**Case File Number: PLN 19158**

<b>Location:</b>	<b>2008 Wake Avenue</b>
<b>Assessor's Parcel Number(s):</b>	018 050800700
<b>Proposal:</b>	Construct a 171,765 sq.ft. 50-foot tall recycling facility on vacant parcel at the former Oakland Army Base. The building will serve as the new California Waste Solutions Recycling (CWS) facility.
<b>Applicant:</b>	RPR Architects
<b>Contact Person/ Phone Number:</b>	Kathleen Rousseau representing California Waste Solutions (CWS) 510-272-0654
<b>Owner:</b>	City of Oakland
<b>Case File Number:</b>	<b>PLN19158</b>
<b>Planning Permits Required:</b>	Major Conditional Use Permit
<b>General Plan:</b>	Business Mix
<b>Zoning:</b>	Gateway District Industrial Zone (D-GI)
<b>Environmental Determination:</b>	TBD
<b>Historic Status:</b>	NA
<b>City Council District:</b>	District 3
<b>Finality of Decision:</b>	NA
<b>For Further Information:</b>	Contact Case Planner: Corey Alvin, (510)238-6316 or <a href="mailto:calvin@oaklandca.gov">calvin@oaklandca.gov</a>

**SUMMARY**

### CONCEPTUAL SITE PLAN

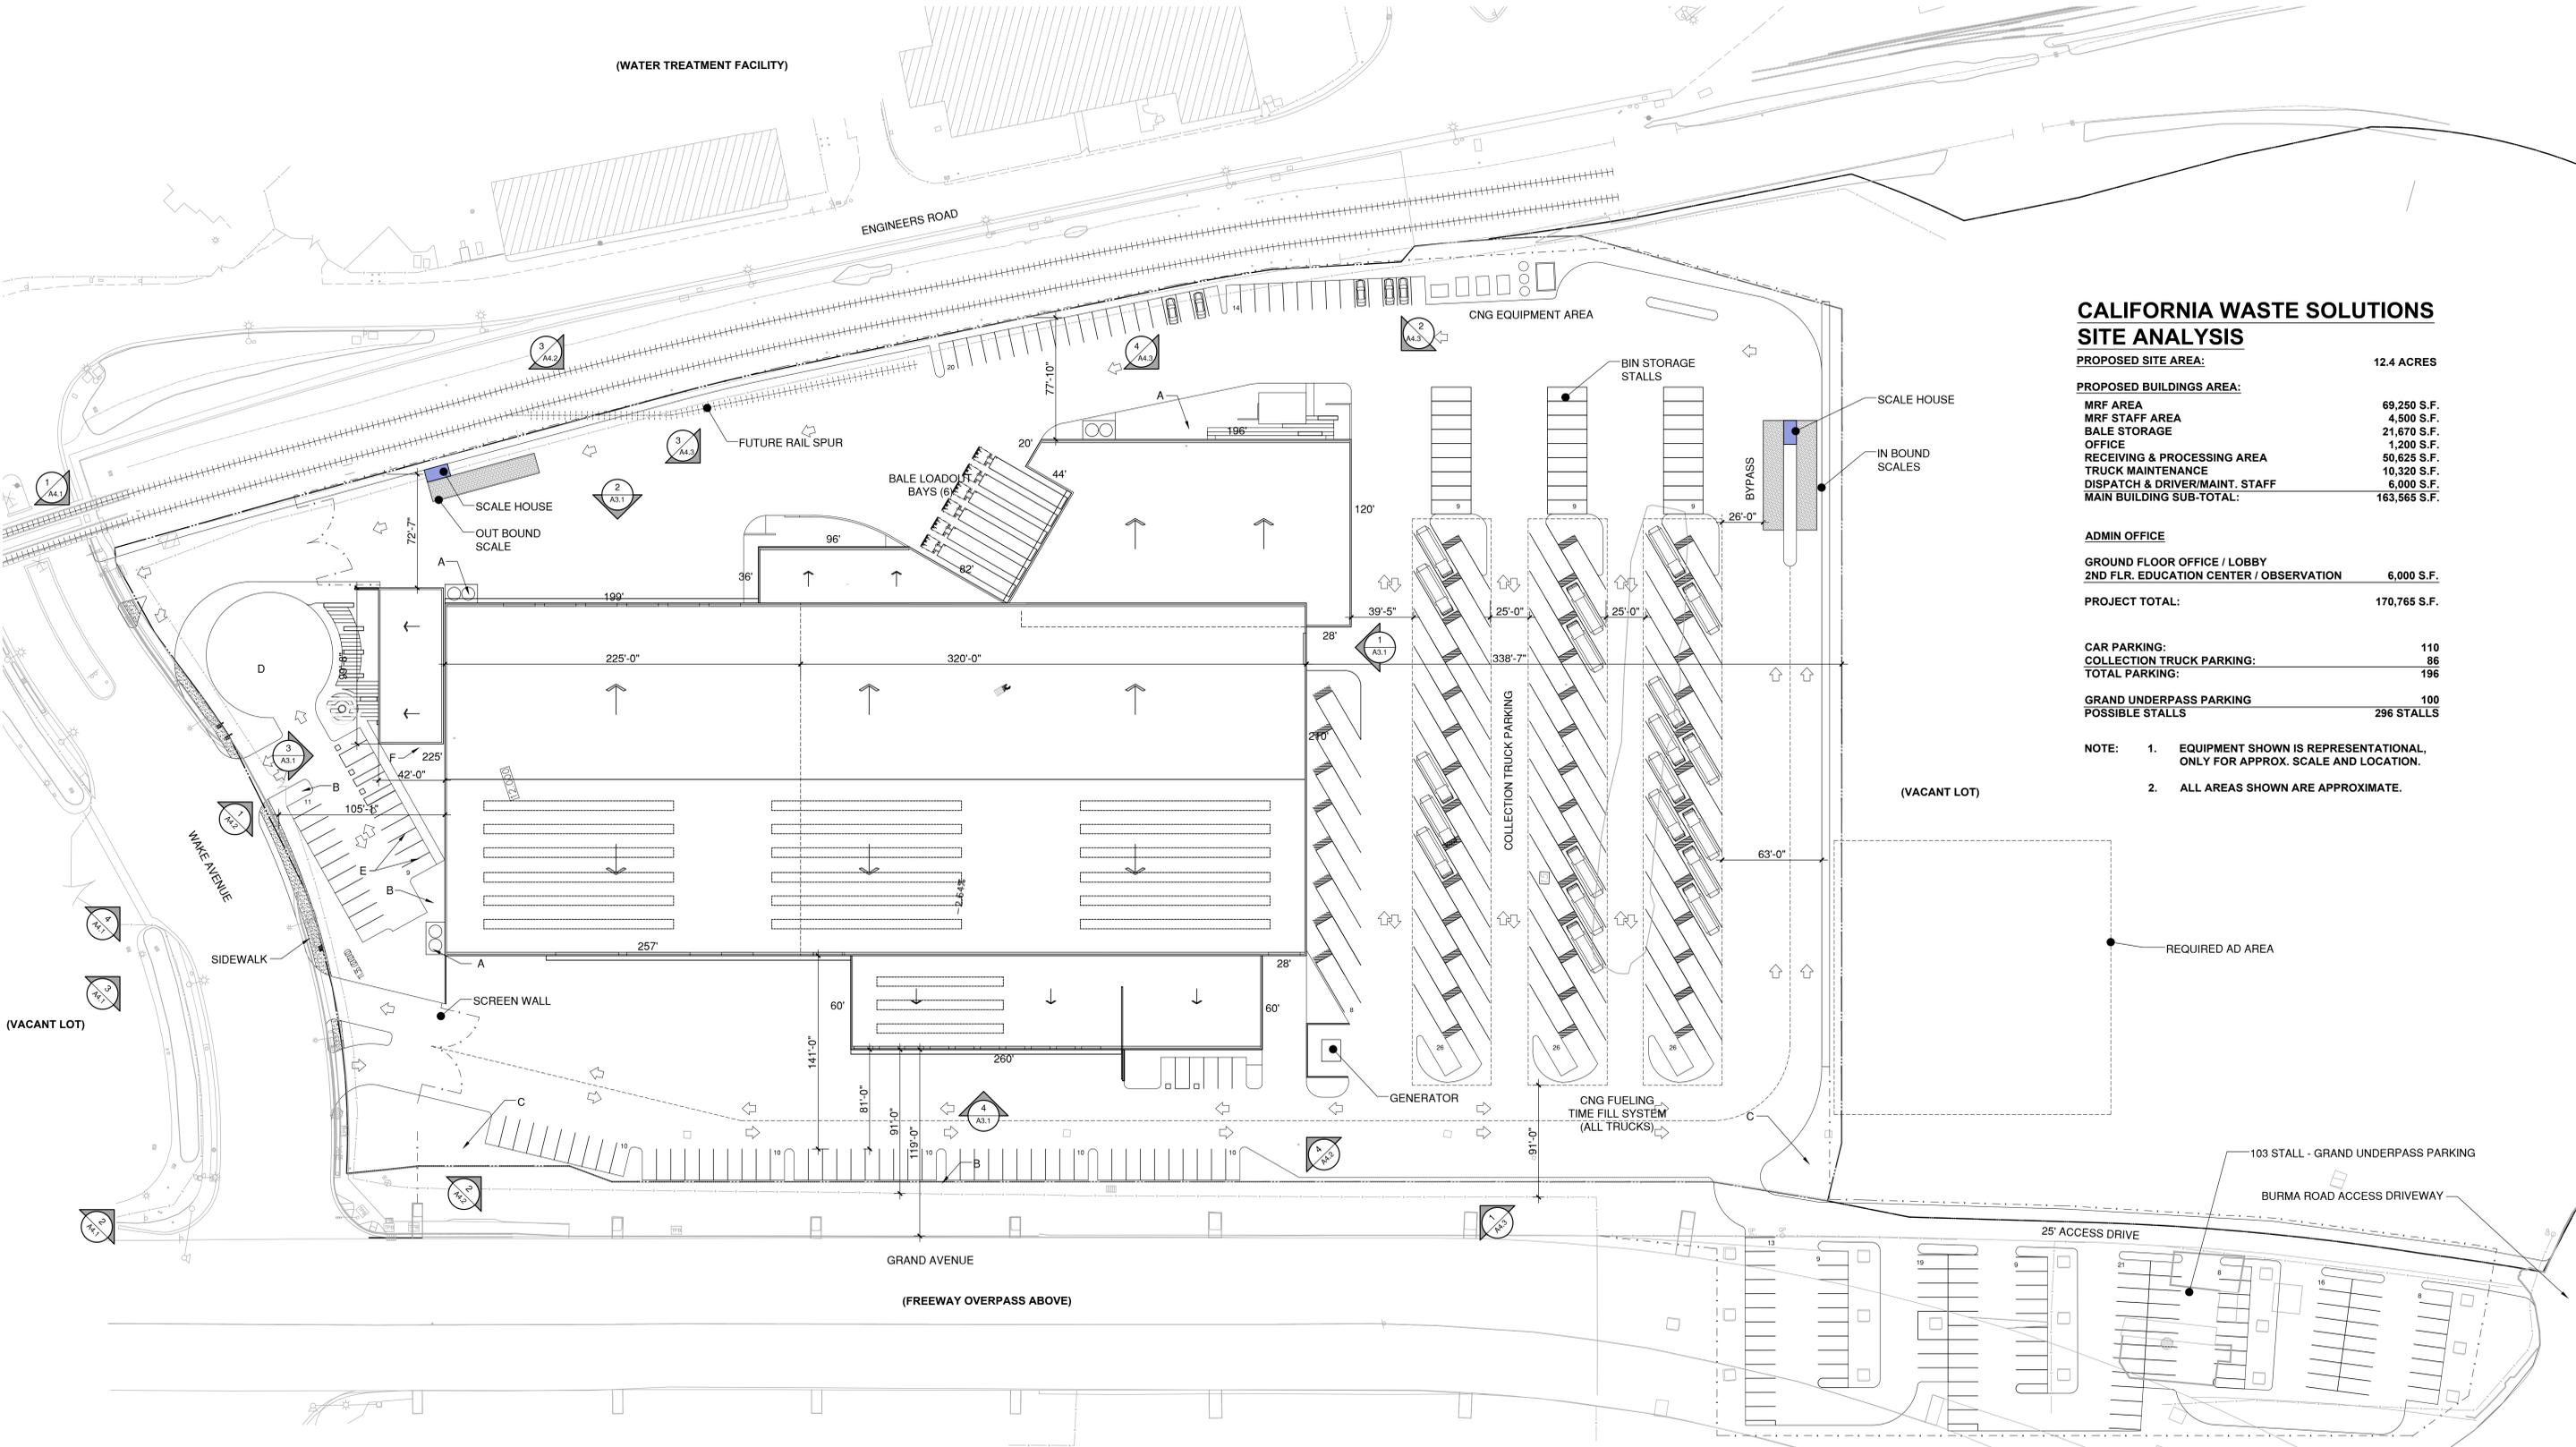
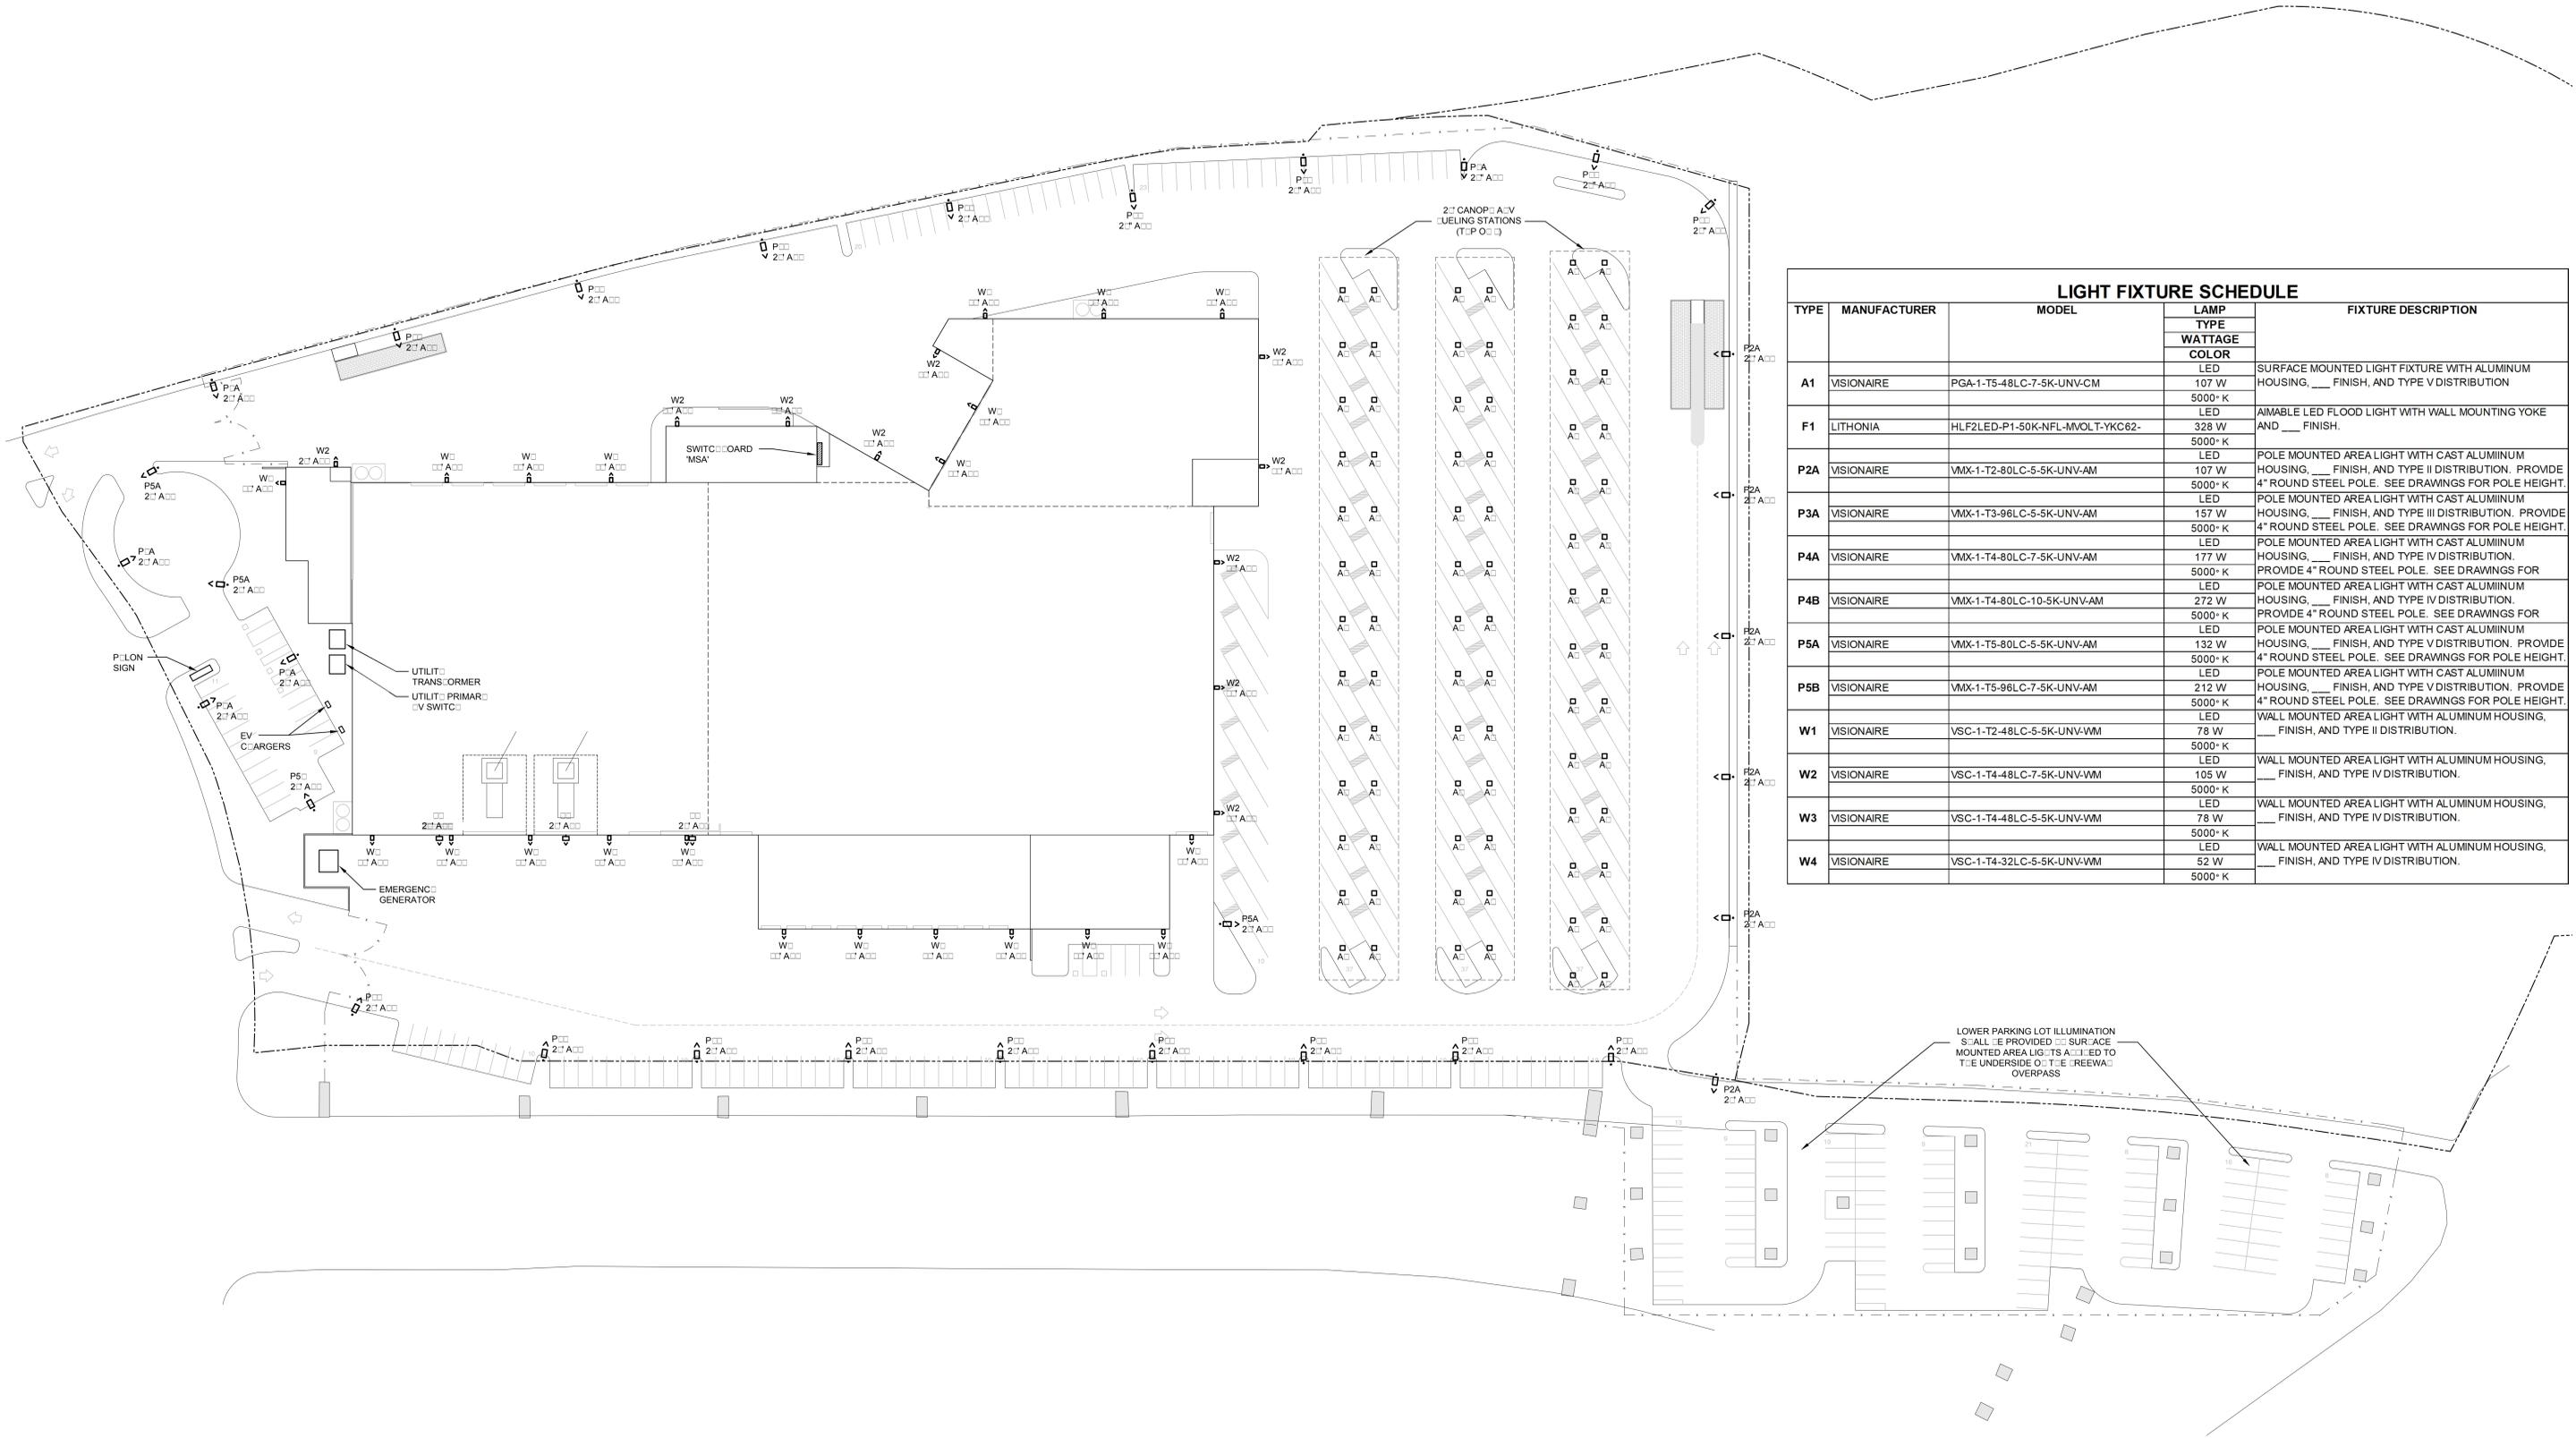
The submitted plans do not show a clear 5-foot pathway from the street and parking areas nor do the plans demonstrate adequate vehicle maneuverability in the parking and truck access areas.
